# ATTACHMENT A

**From:** Yip, Queenie FLNR:EX <Queenie.Yip@gov.bc.ca>  
**Sent:** Thursday, May 12, 2022 1:39 PM  
**To:** Gerald Schlesiger  
**Subject:** RE: Official Community Plan Amending Bylaw 6095-2022-5670(33) - Waterfront Revitalization Master Plan

**Subject:** RE: Official Community Plan Amending Bylaw 6095-2022-5670(33) - Waterfront Revitalization Master Plan

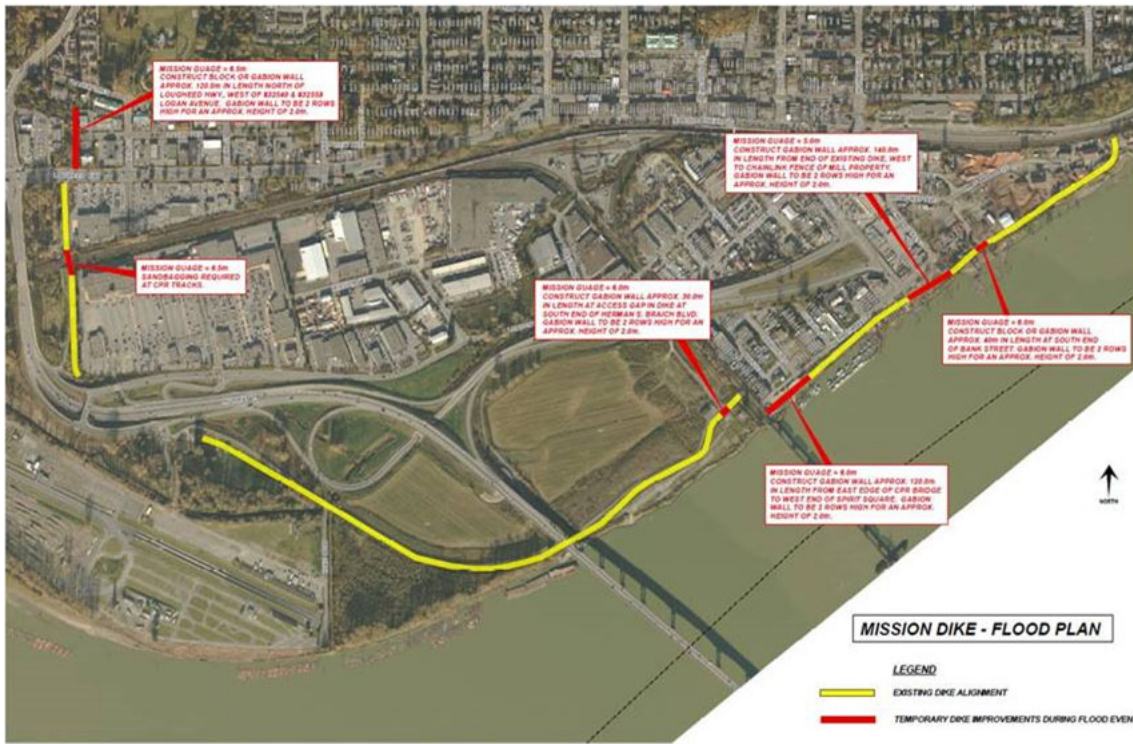
Point #4 was mainly on the discussion of the upstream side of Mission Waterfront. Below is the location where Mission requested for Hesco Basket from PREOC in 2020. I understand that Mission placed lockblocks every freshet in the area. If the parcel behind the raised land on the east side of Waterfront depends on protection from the dike and there is no dike, what is the plan? Mission cannot, in a long term, depends on Province's support in flood response in the area, at the same time, putting additional developments in the area. This is putting more liability to the Province during flood response and recovery. If the parcel that is raised will act as a dike, raising of the land will need approval from the Inspector of Dike (IOD) office.
